NATIONAL ENERGY BOARD

**an application by Trans Mountain Pipeline ULC
as General Partner of Trans Mountain Pipeline L.P.
(collectively “Trans Mountain”)
for a Certificate of Public Convenience and Necessity and
other related approvals pursuant to Part III of the *NEB Act***

**TRANS MOUNTAIN EXPANSION PROJECT
REPLY EVIDENCE**

August 2015

6 **Figure 2-1 IEA WEO2014 World Oil Demand and Oil Price by Scenario**

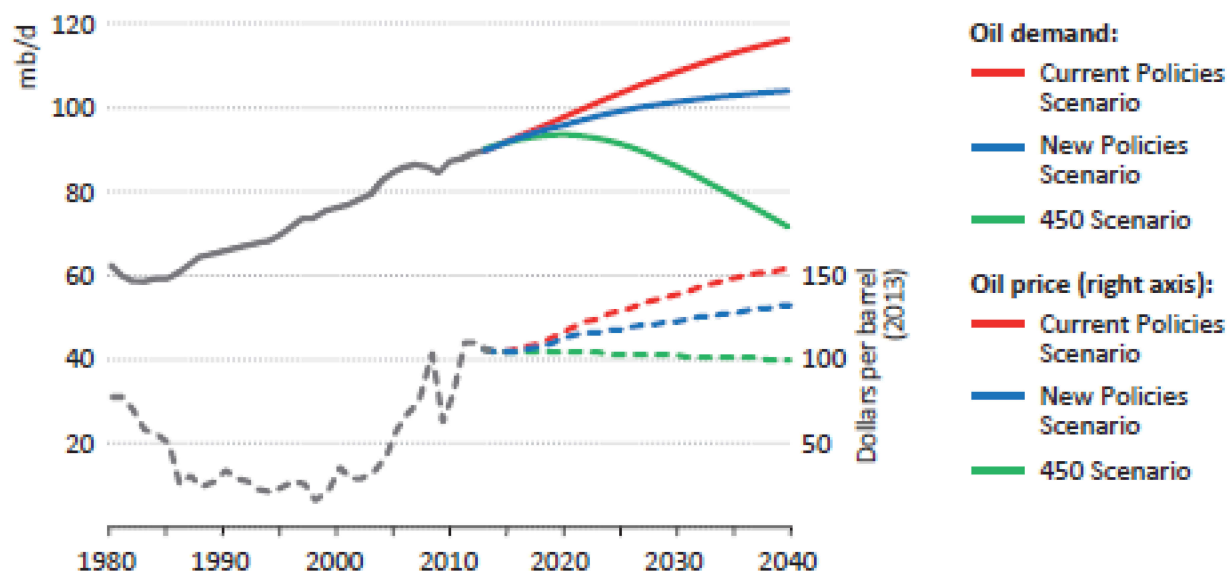
The scenario that Dr. Harrison is assuming in her evidence is the 450 Scenario, in which it is assumed that the international community takes actions to achieve ambitious targets for GHG reductions. This scenario is not the New Policies Baseline Scenario that the IEA uses in its 2014 World Energy Outlook. As stated by the IEA:

1 Figure 2-1 compares the world oil demand and crude price forecasts, for each of the three
2 scenarios included in the IEA WEO2014, and illustrates the wide difference between the New
3 Policies Baseline and 450 Scenarios.

IHS believes that the New Policies Baseline Scenario provided by the IEA, the most respected independent global authority on world energy matters, is a far more likely scenario to unfold than the 450 Scenario assumed by Dr. Harrison. As noted above, the New Policies Baseline Scenario incorporates the expected impacts of announced climate change policies, including national pledges to reduce greenhouse gas emissions, up to the point at which the analysis for the 2014 World Energy Outlook was completed.

Figure 33.2-1 Trans Mountain Dispersion Modelling Receptors over Conceptual Water Lot Lease Boundary

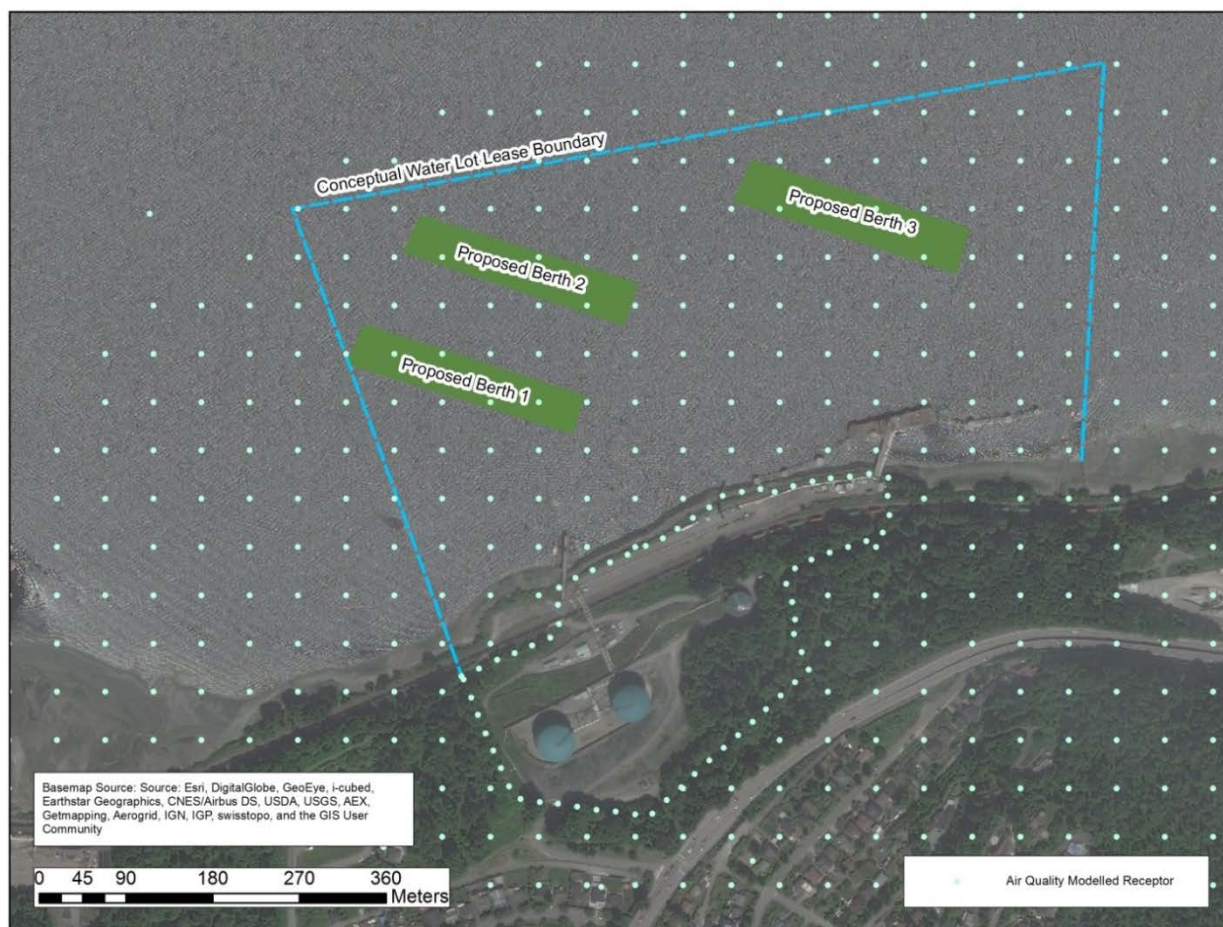
Furthermore, as stated in the Novus report, the exceedances predicted in the Novus study with 99% collection efficiency do not occur at any sensitive or public receptors (Filing ID [A4L8A2](#)). They are mostly localized (Figure 7 of the Novus report, Filing ID [A4L8A2](#)) in the Westridge

Marine Terminal conceptual water lot lease boundary, as shown in Figure 33.2-, where there is no public access.

Figure 33.2-2 Predicted Maximum 1-Hour SO₂ Concentrations Including All Marine Transportation and Westridge Marine Terminal Operations, Cumulative Case (in µg/m³)

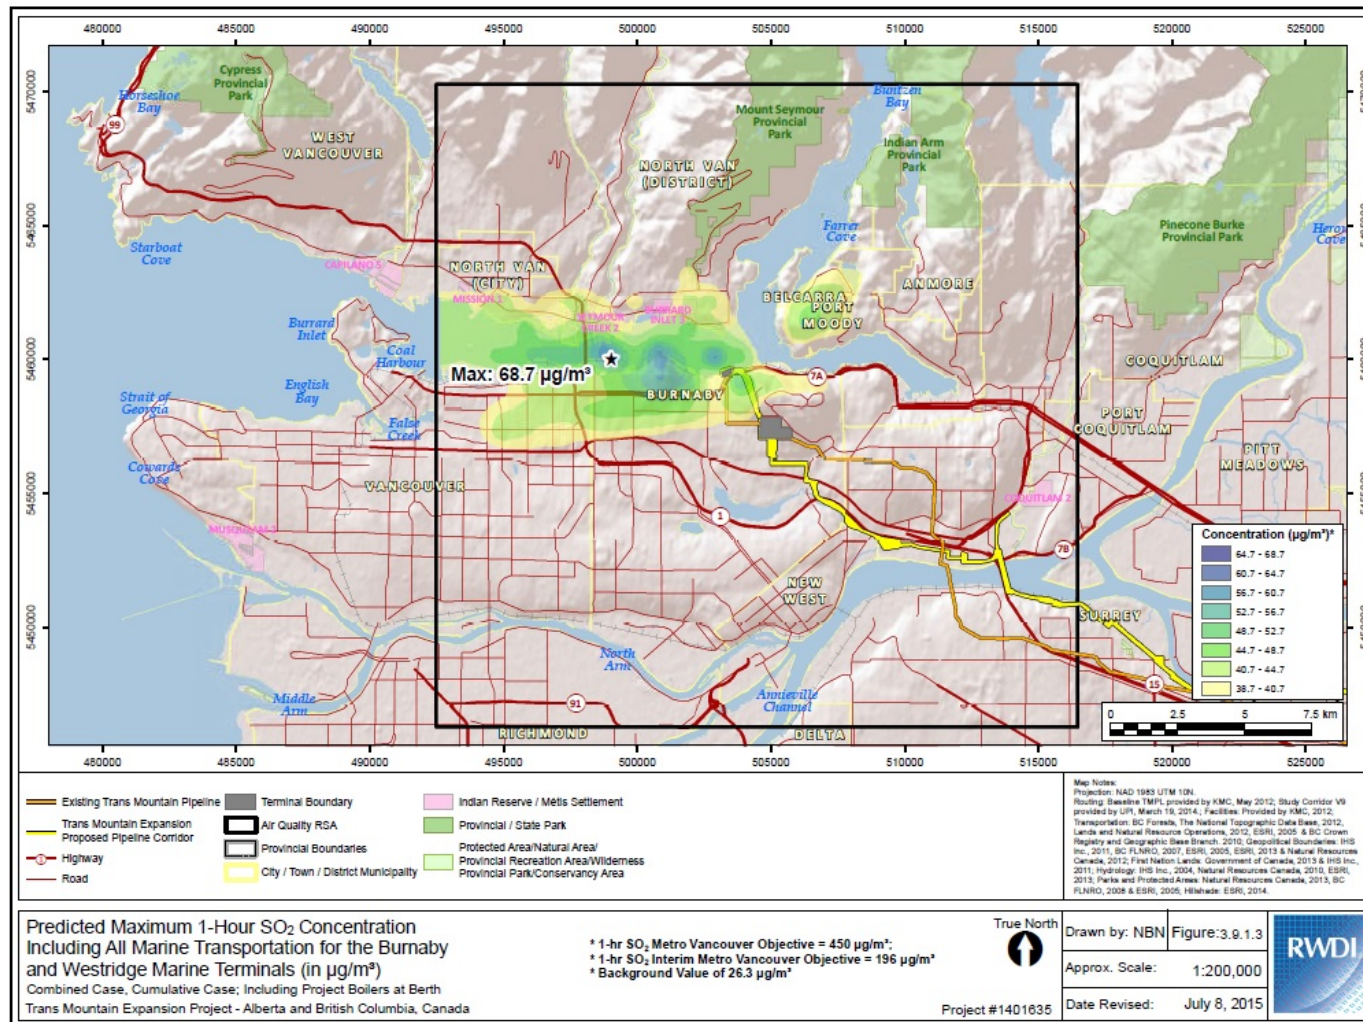
MV: Section 3.9.1.2 of MV's evidence (Filing ID [A4L7Y3](#)) requested an explanation for the lower nitrogen dioxide (NO₂), particulate matter less than 2.5 µg/m³ (PM_{2.5}) and particulate matter less than 10 µg/m³ (PM₁₀) concentrations predicted in the Supplemental Air Quality Technical Report for Technical Update No. 2 (August 2014) ([A4A4E3](#)) as compared to the Technical Report 5C-4 of Volume 5C, Air Quality and Greenhouse Gas Technical Report (Figures 5.7, 5.9 and 5.11, Filing ID [A3S1U2](#)).

The maximum predicted SO₂ concentration is about a third of the proposed MV 1-hour objective of 196 µg/m³. Figure 33.2-2 displays contour levels from these predicted concentrations.

Figure 33.2-3 Predicted Maximum 1-Hour NO₂ Concentration Including All Marine Transportation for the Burnaby Terminal and Westridge Marine Terminal (in µg/m³)

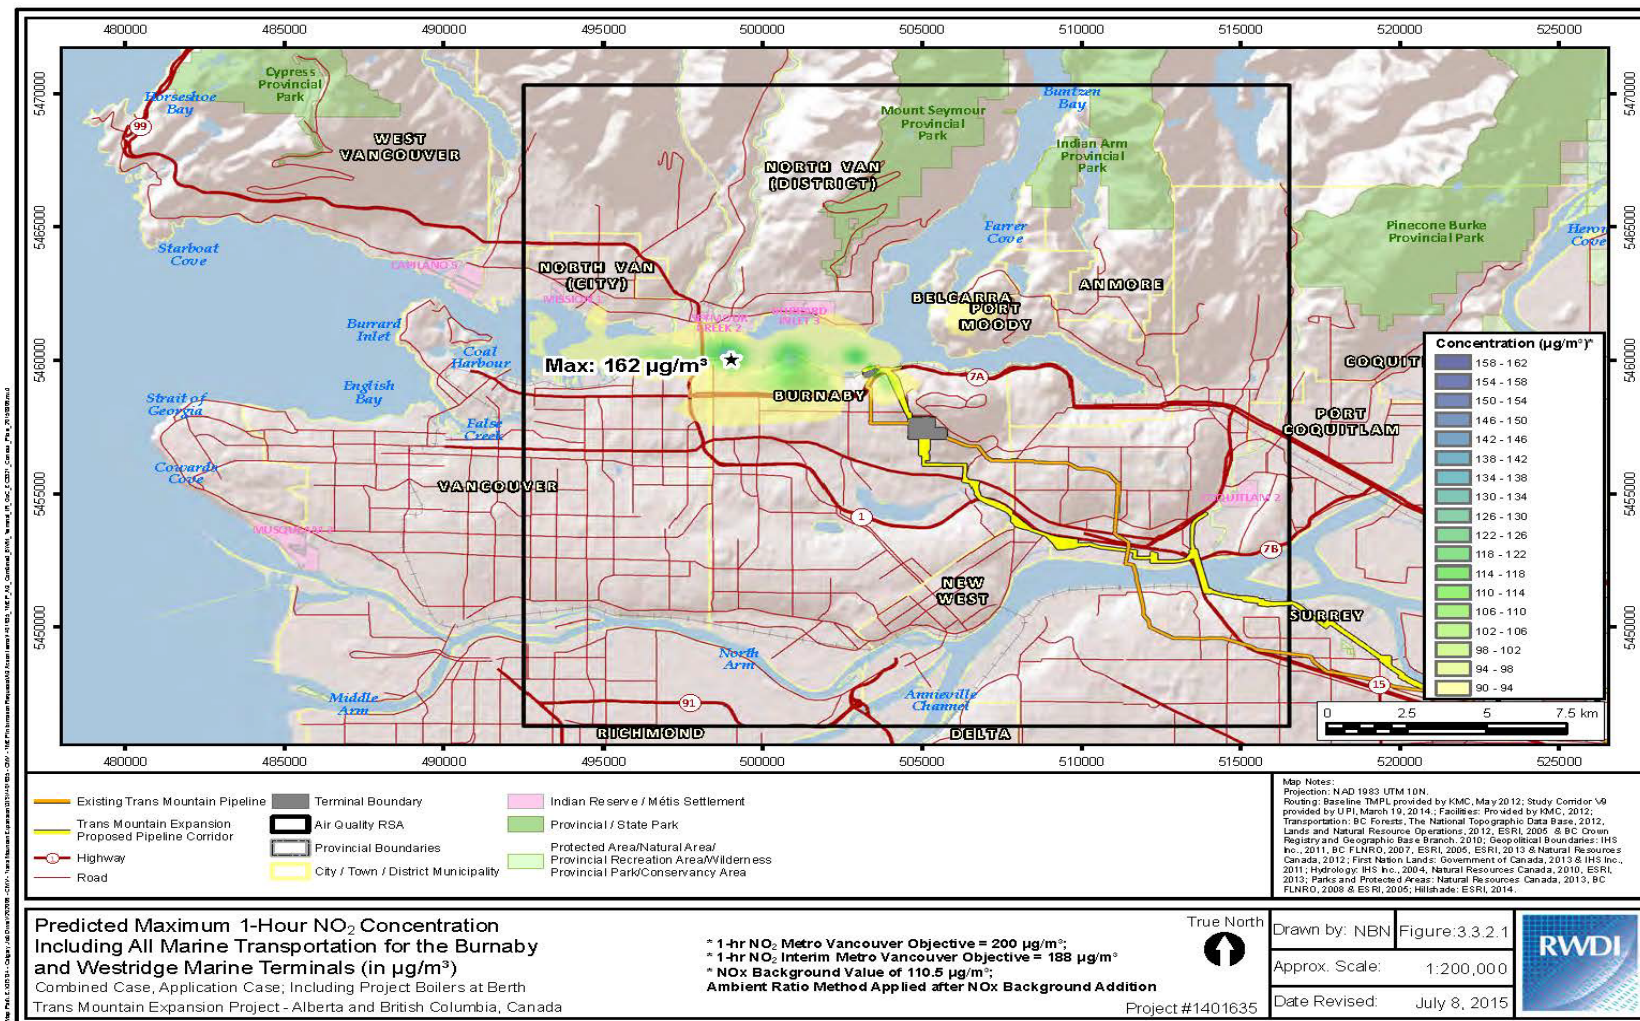
BROKE and NS NOPE (Takaro et al.): BROKE and NS NOPE filed a report written by Dr. Takaro et al. (Filing ID [A4L6U5](#)) which expresses several health and air quality concerns. Section 7.1.1.1 of the report raised the concerns about existing high SO₂ and PM ambient background values exceeding or nearly exceeding the objectives.

Figure 33.2- displays the concentration contour plots maximum predicted 1-hour NO₂ concentrations for the combined effects of emissions from Burnaby Terminal, Westridge Marine Terminal and all marine transportation traffic (using the MEIT) for the Application Case including Trans Mountain boiler emissions at berths.

Figure 35-4 The Self-Assessment Process for the Trans Mountain Expansion Project

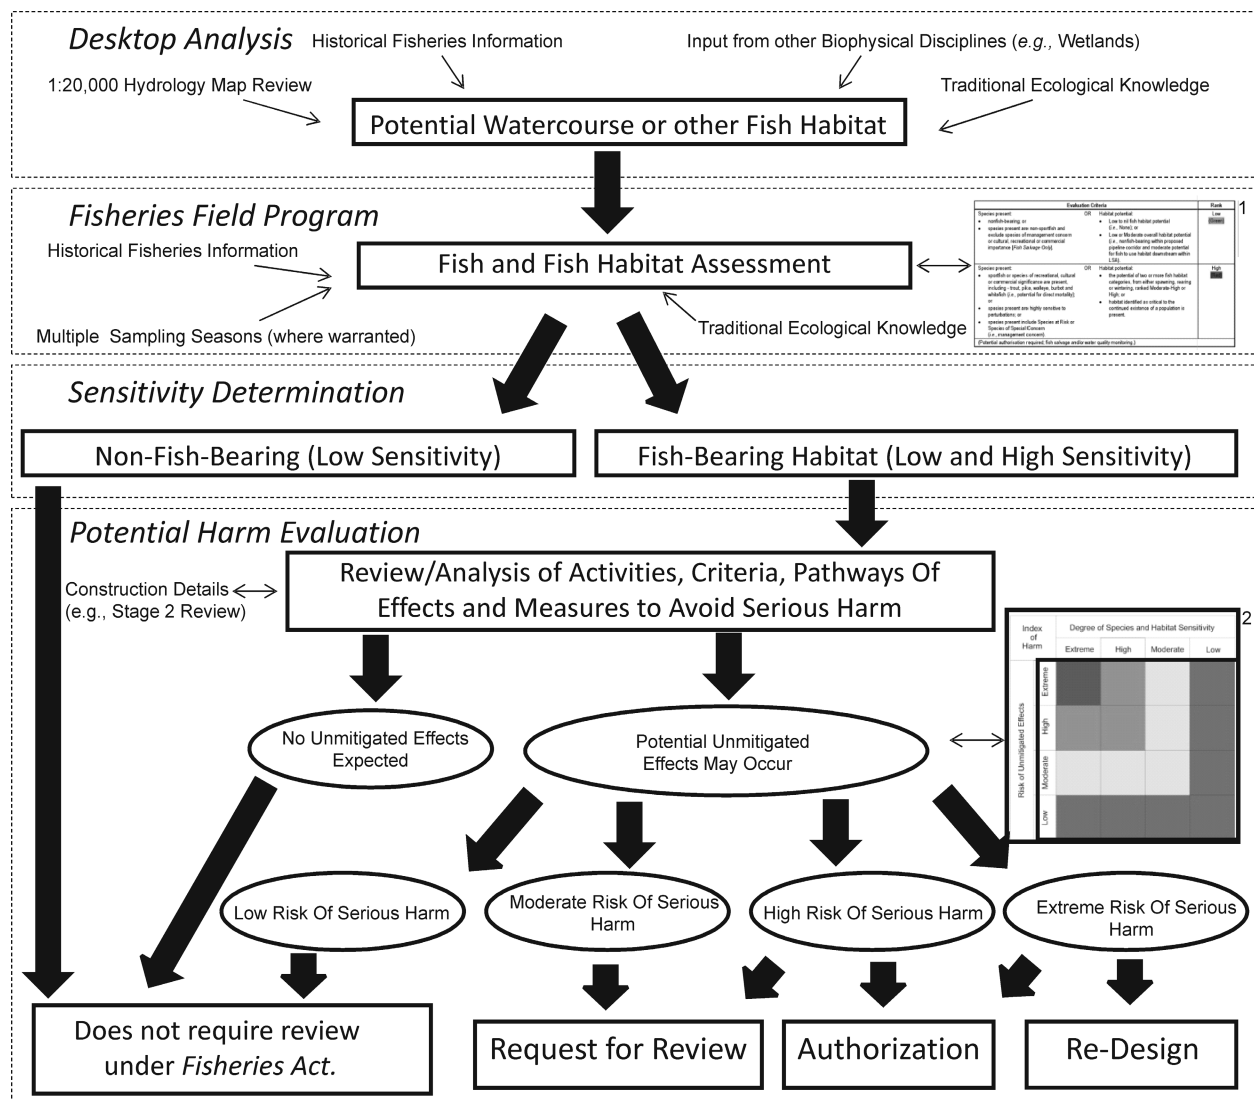
26 The strategy of incorporating traditional knowledge and information into the overall sensitivity of
27 freshwater environments traversed by the PPC and, therefore, in the consideration of potential
28 serious harm is summarized in Figure 2 of the Project's Self-Assessment (Filing ID [A4I6C1](#)) and
29 presented again below for convenience (Figure 35-4). Trans Mountain remains confident in its
30 incorporation (and commitment for continued engagement) of Traditional Ecological Knowledge
31 (TEK) and TLU information, including that focusing on Stó:lō Collective information, into the
32 Project. This position is supported by observations made by other intervenors, most notably in
33 evidence provided by Cowichan Tribes (Filing ID [A4Q0U9](#)):

Trans Mountain maintains that the Self-Assessment was completed under requirements of the revised *Fisheries Act*, in adherence to DFO endorsed self-assessment process and with particular reference to the Project's relevant DFO Pathways of Effects (PoE). By definition under federal legislation and associated policy, the Self-Assessment considered, equally, CRA fisheries and those fish species and their habitats that contribute to the sustainability of the CRA fisheries. As such, under the auspices of the *Fisheries Act*, Trans Mountain maintains that all fish species that may be part of a traditional use fishery, will, inherently, be protected. Where information about Aboriginal Fisheries was unavailable, the Project took a conservative approach and assumed that Aboriginal Fisheries occur at all fish-bearing crossings. As such, each of these crossings where social, ceremonial, or sustenance uses could be anticipated or is confirmed were included in the Self-Assessment by default.
